Evaluation of Relay Frame Structures and Recommendations for Changes

IEEE C802.16m-08/1058r1

SDD Session 56 Cleanup: Material in support of SDD comments on relay frame structure. For discussion and adoption by the TGM

Proposed modifications to Option 1 FS to support SCH/BCH and MBS transmissions

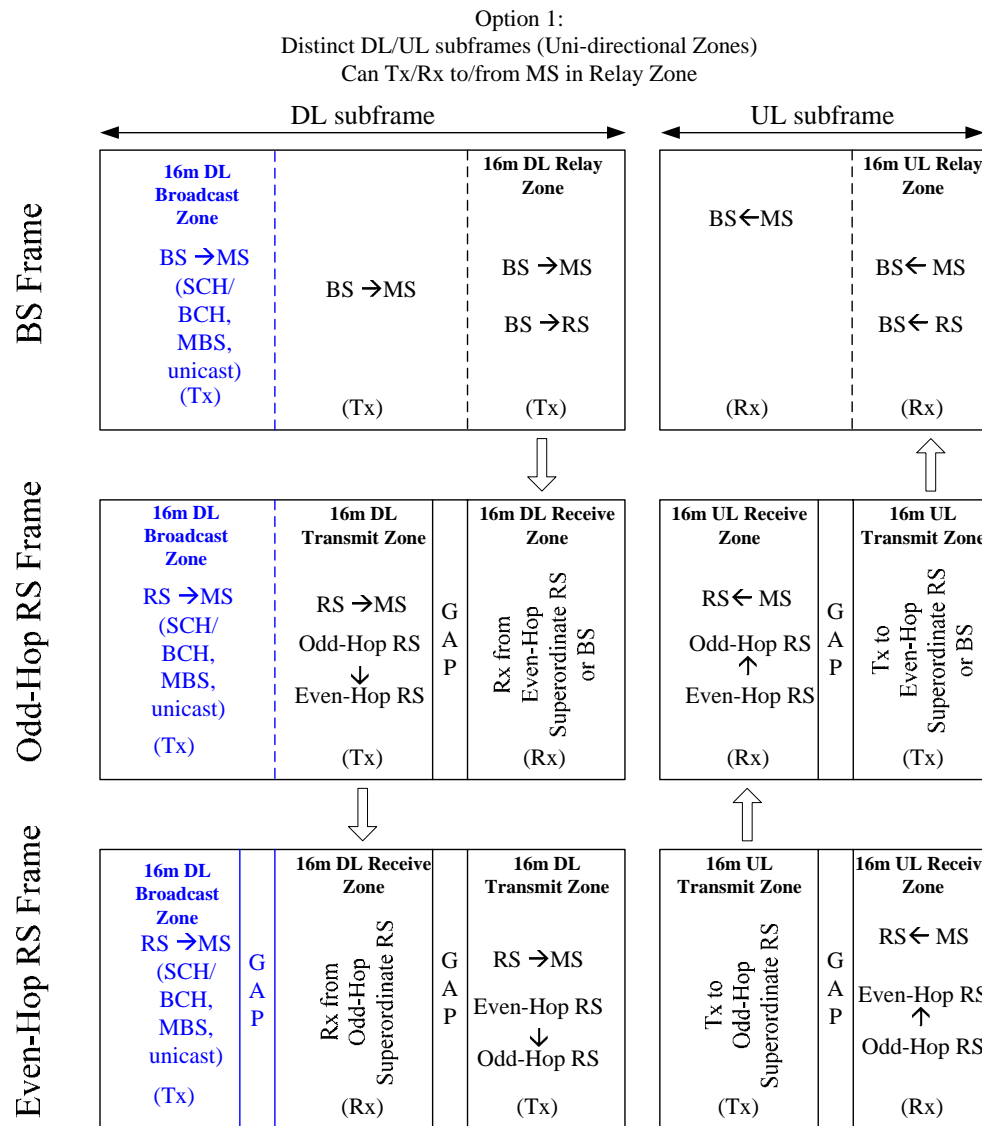
- It is not clear how SCH/BCH broadcast and MBS are supported in FS Option 1 because Even hop RSs do not transmit to the MSs at the same time as the BS and Odd hop RSs in the current option 1 FS.
- We propose that an additional zone be added to the DL portion of the Option 1 FS in order to provide a common place for SCH/BCH and MBS transmissions
 - SCH/BCH and MBS are synchronized across relay and non-relay sectors
 - An additional gap is required for even hop RSs and one possible DL/UL ratio is eliminated
 - See DL/UL ratio and Switching point analysis for details

Sector Throughput in FS Option 2 DL with Spatial Multiplexing

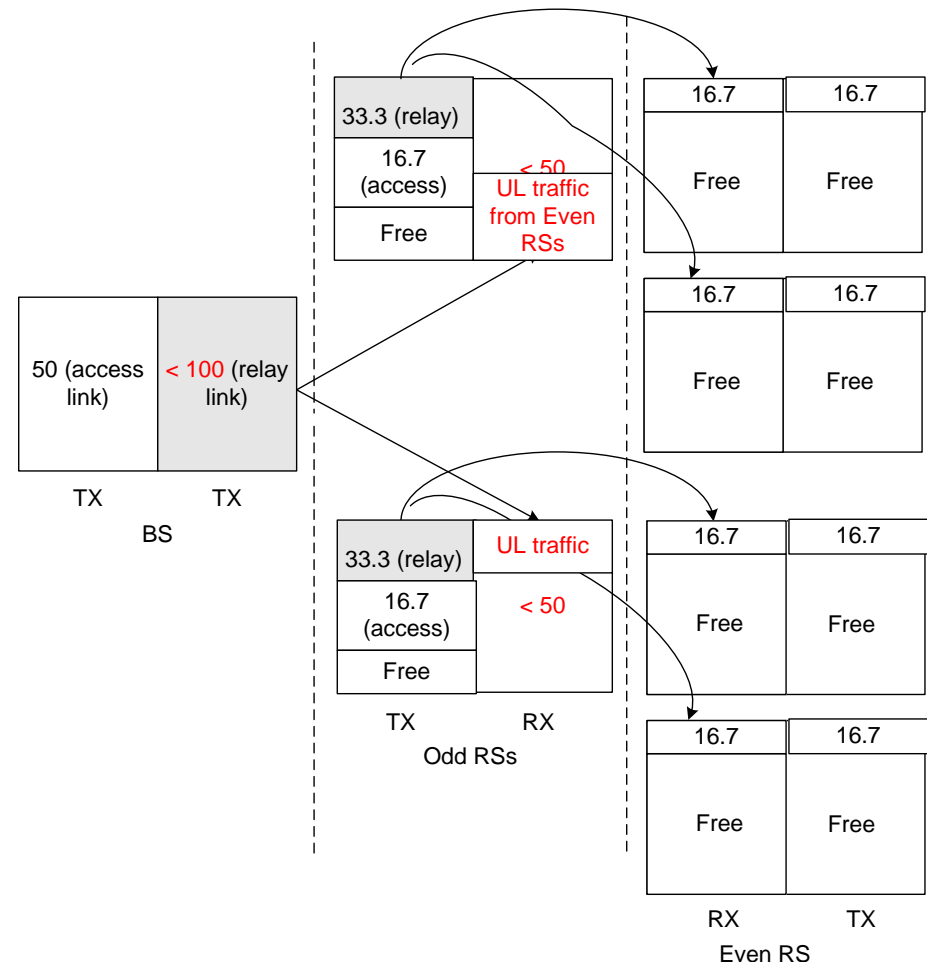
- Relay zone in Option 2 BS frame structure supports BS-RS DL and RS-RS UL
- BS cannot easily transmit to RSs during the part of the zone in which they receive UL transmissions from their subordinates
 - This either results in a decrease in maximum sector throughput
 - Or RS must implement complex SM techniques allowing BS and subordinate RS to transmit different data streams simultaneously; Variant B of symbol structure would need to be used, increasing pilot overhead

Switching Point Overhead

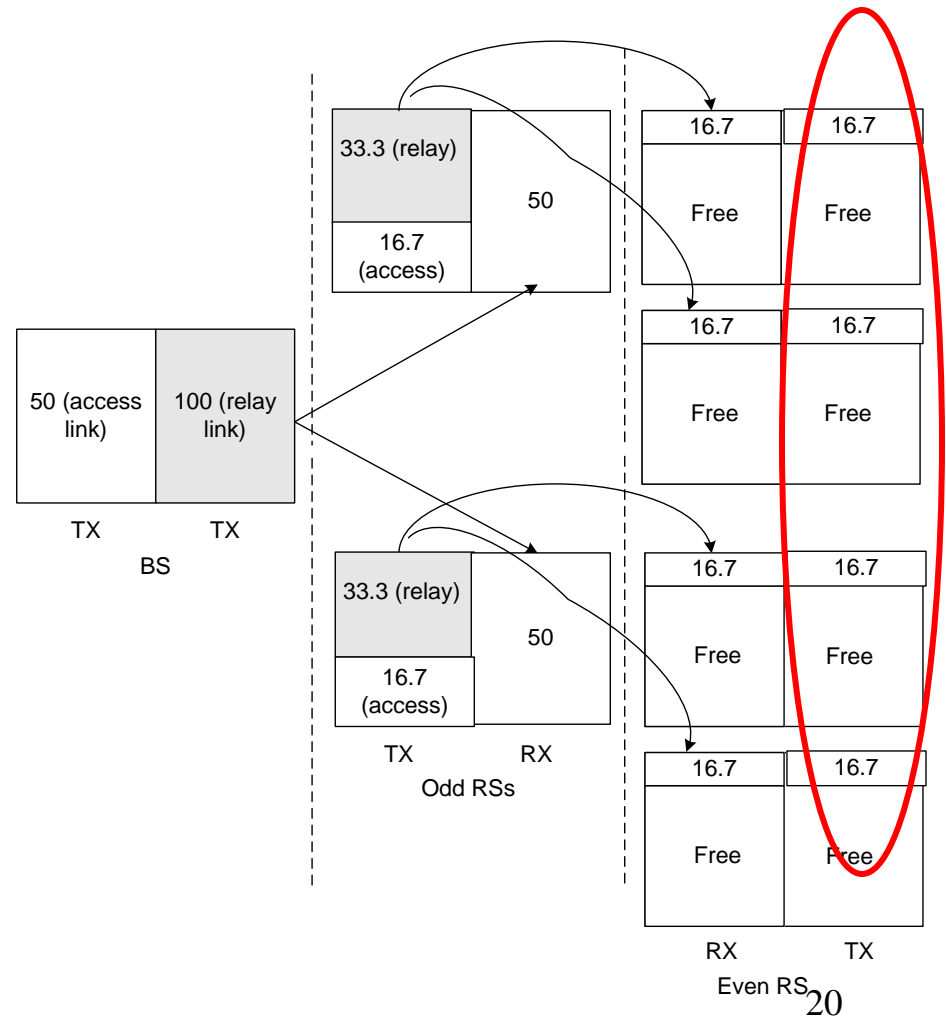
- FS Option 1 has 3 extra switching points in even tier RSs.
- Assume the same example as in slide 16.
- Because amount of traffic transmitted by the third tier RSs is smaller than the previous tier, these extra gaps should have no effect on capacity

DL/UL Ratios with Option 2

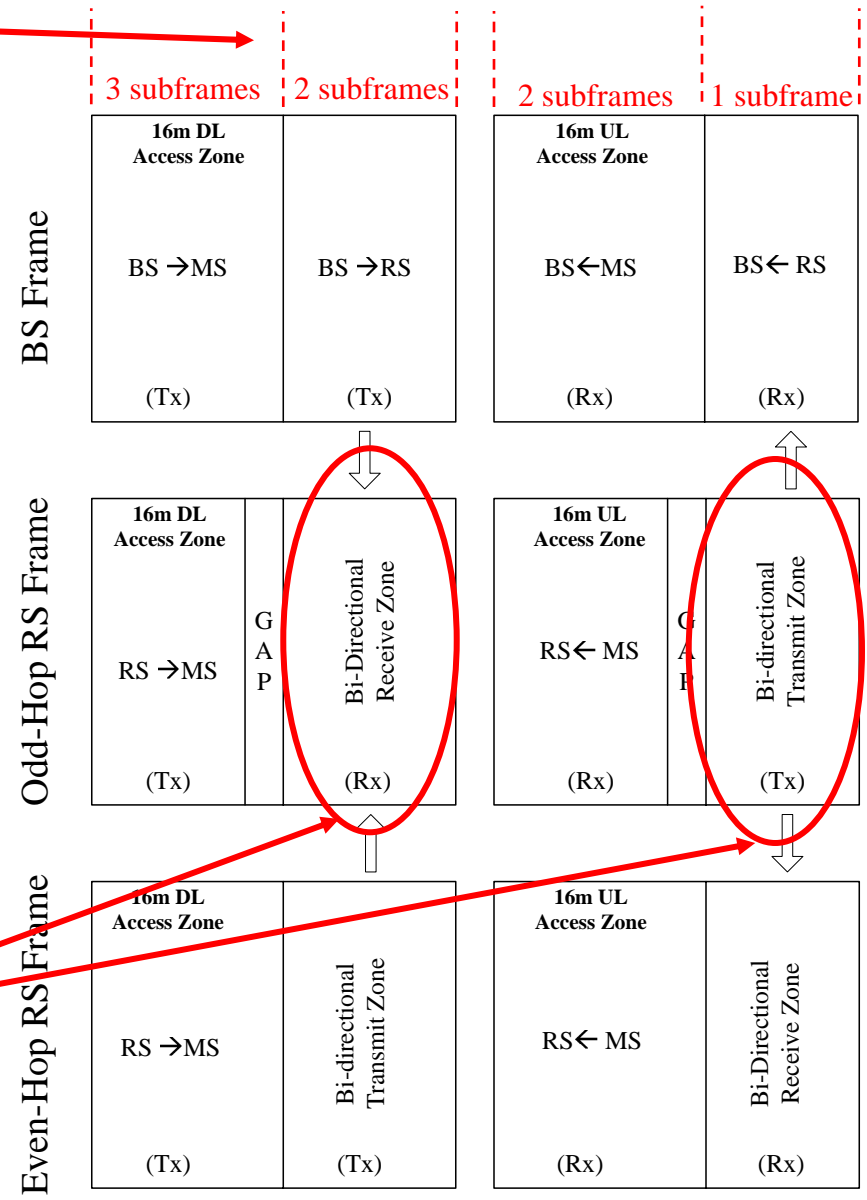
Zones must be split according to DL/UL ratio because all traffic flows through the BS, so the DL/UL ratio must exist in the BS frame

- In example on the right we assume DL/UL Ratio of 5:3
- 6:2 ratio is more problematic
- 2:6 and 3:5 ratios are also problematic, but these are not commonly used.

Odd hop RS receives 2 subframes of DL data from BS has only 1 subframe to transmit DL data to its subordinates

Adding Broadcast zone to FS Option 1

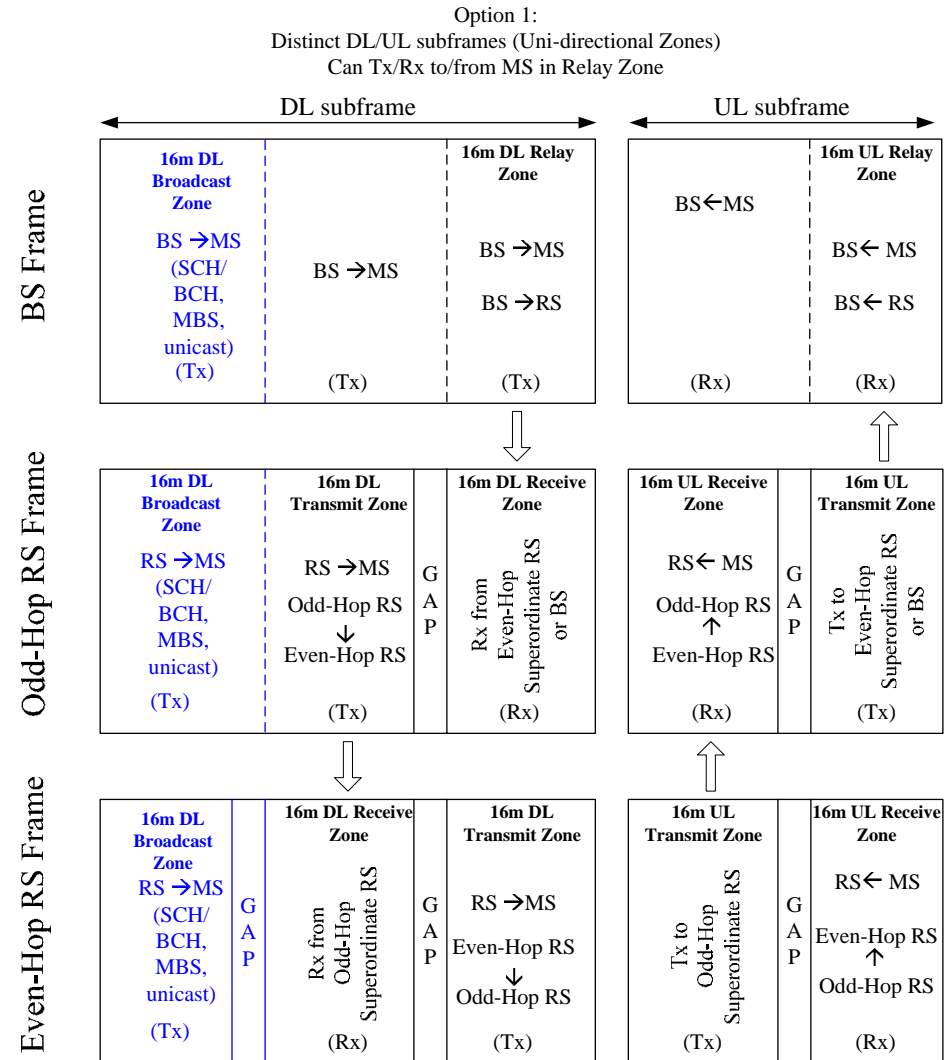
[Modify figure 23 on page 40 as indicated in the figure on the right]

[Add the following text to the list of definitions that follow figure 23 on page 40 and 41]

- 16m DL Broadcast Zone: An integer multiple of subframes located in the 16m zone of the DL of the 16m BS frame or 16m RS frame, where a 16m BS or a 16m RS transmits the SCH and BCH. MBS transmissions and unicast transmissions to the MSs may also occur in this zone.
